REQUEST FOR WRITTEN APPROVAL TO USE CONSTRUCTION METHODS NOT INCLUDED IN OREGON ADMINISTRATIVE RULES 690-200 THROUGH 690-240

Date of request: 12-15-95

(1) Location of Well: N.E. 1/4 N.E. 1/4 of Section 72
Township 2 S., Range 4 E., CLACK County.
Address at well site: 14385 S.E Lusted Rd Sandy Or.

(6) Start Card #: (7) Diagram showing the pertinent features of the proposed well design and construction:

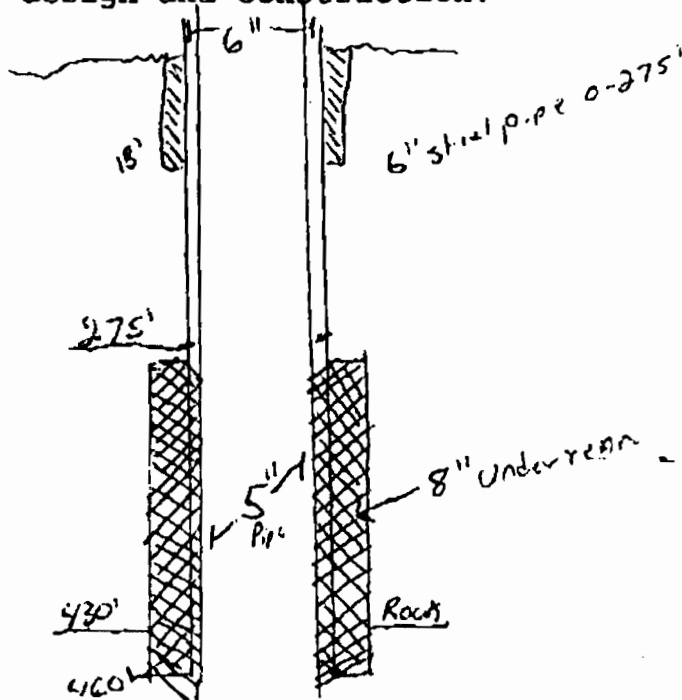
(4) The unusual conditions which necessitate this request: _____
6" Steel Pipe Will Not Drive. Need To Seal Into Rocks With 5" Steel pipe.

(5) The proposed construction methods that the well constructor believes will be adequate for this well (attach additional pages if needed). This Well Is To Be Under Permeated From 6" To 8" From 275' To 460' And 5" Steel 250 pipe Installed From 41' To 460' After Cement Has been pumped By Way Of Test pipe From 460' up to 275'.

w-as
remarks: underream lower seal
